Docket No. 50-443  
SBK-L-04116

**Supplemental Response to Request for Additional Information (RAI Nos. 2 and 3) Regarding  
License Amendment Request 04-03, Application for Stretch Power Uprate**

**Enclosure to Letter No. SBK-L-04116**  
**Supplemental Response To Request for Additional Information**  
**(RAI Nos. 2 and 3)**  
**for**  
**LAR 04-03, Application for Stretch Power Uprate**

Figure RAI 2-1

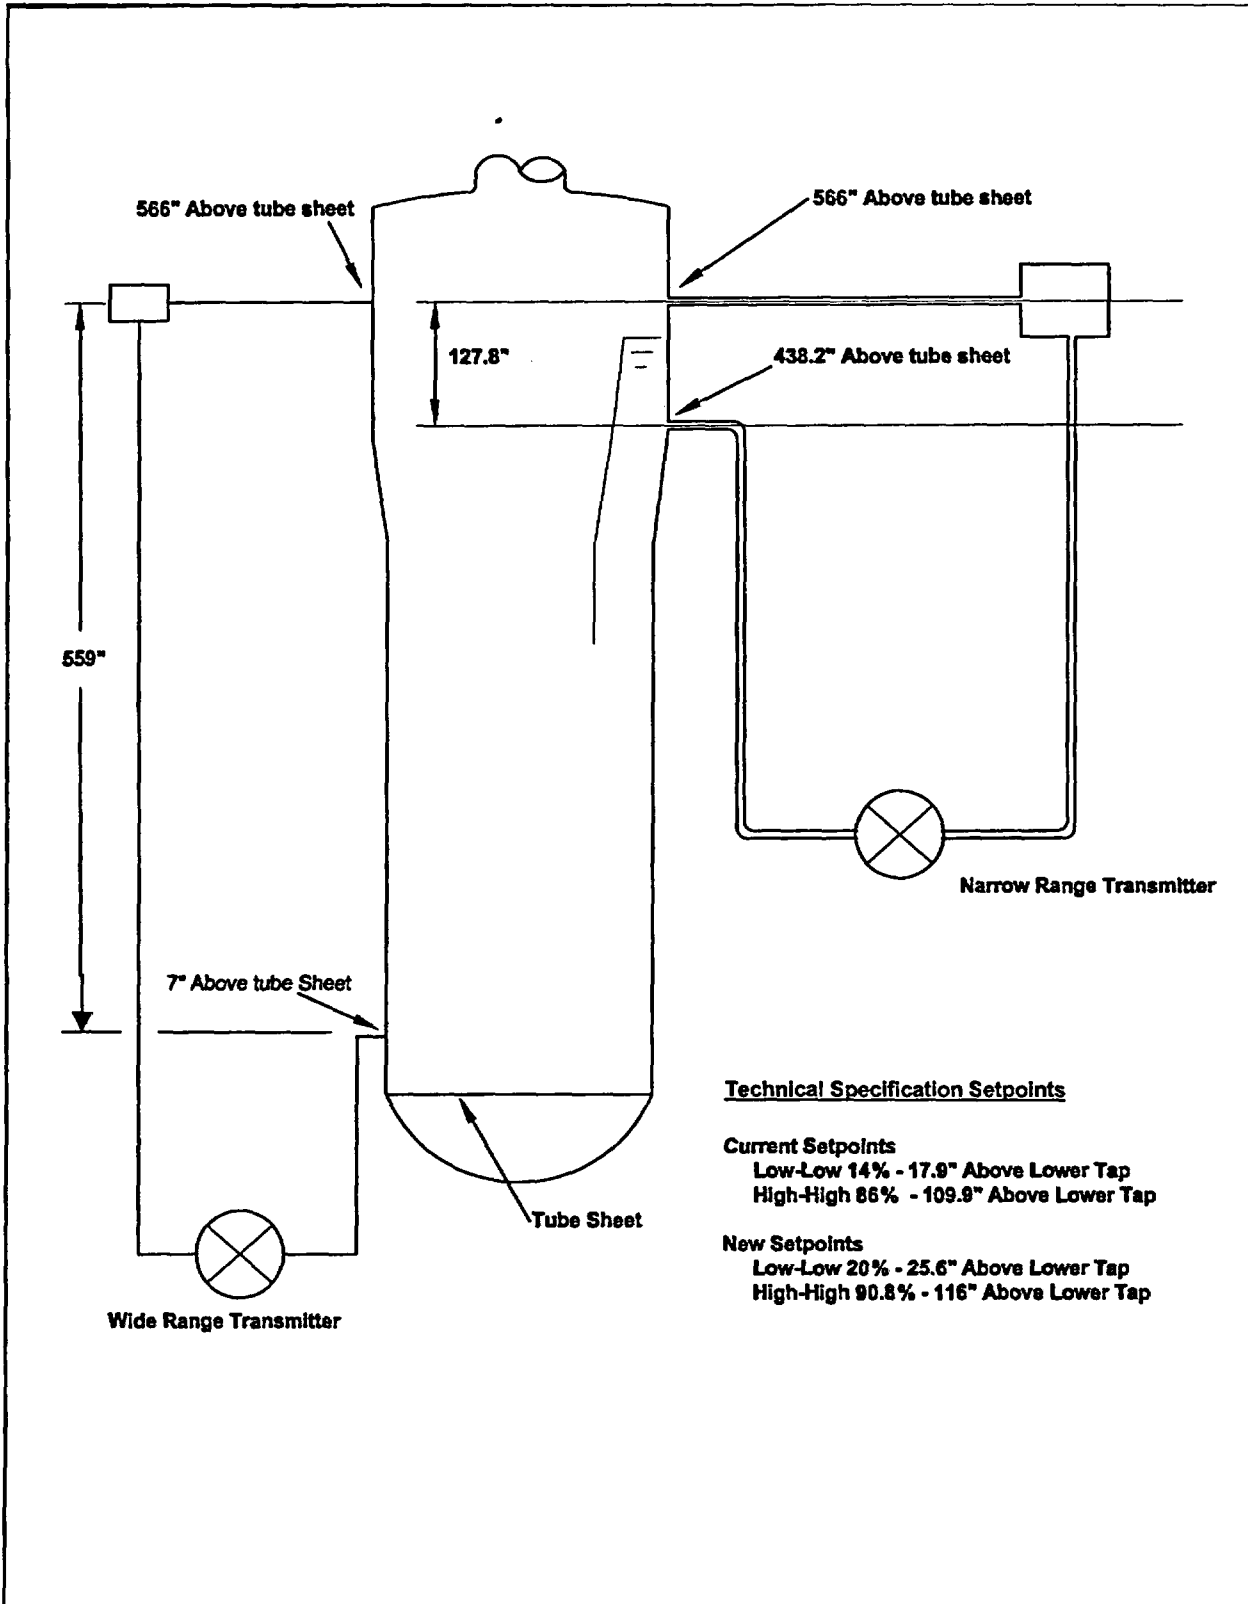
In each case where a setpoint is shown as a percentage of instrument span, identify the instrument by manufacturer, model and range, its span, and the actual and allowable physical values of the setpoint.

For steam generator level, the transmitters are Rosemount model 1154DP4RA and the process racks are Westinghouse 7300 racks. The narrow range span is defined as the distance between the lower instrument tap and the upper instrument tap. The distance is 127.8 inches – see Figure RAI 2-1. The transmitter range is 150 inches of water column (W.C.) and the calibrated span is 85.72 inches of water column. The process rack range and span is 0 – 10 volts D.C. The physical unit of measure for this function is level. Based on the tap to tap distance of 127.8 inches, the previous Technical Specification low level setpoint of 14% narrow range span is 17.9 inches above the lower tap and the previous Technical Specification high level setpoint of 86% narrow range span is 109.9 inches above the lower tap. The setpoint change for the SPU is 20% of narrow range span which is 25.6 inches above the lower tap and the high level setpoint change is 90.8 % of narrow range span which is 116 inches above the lower tap.
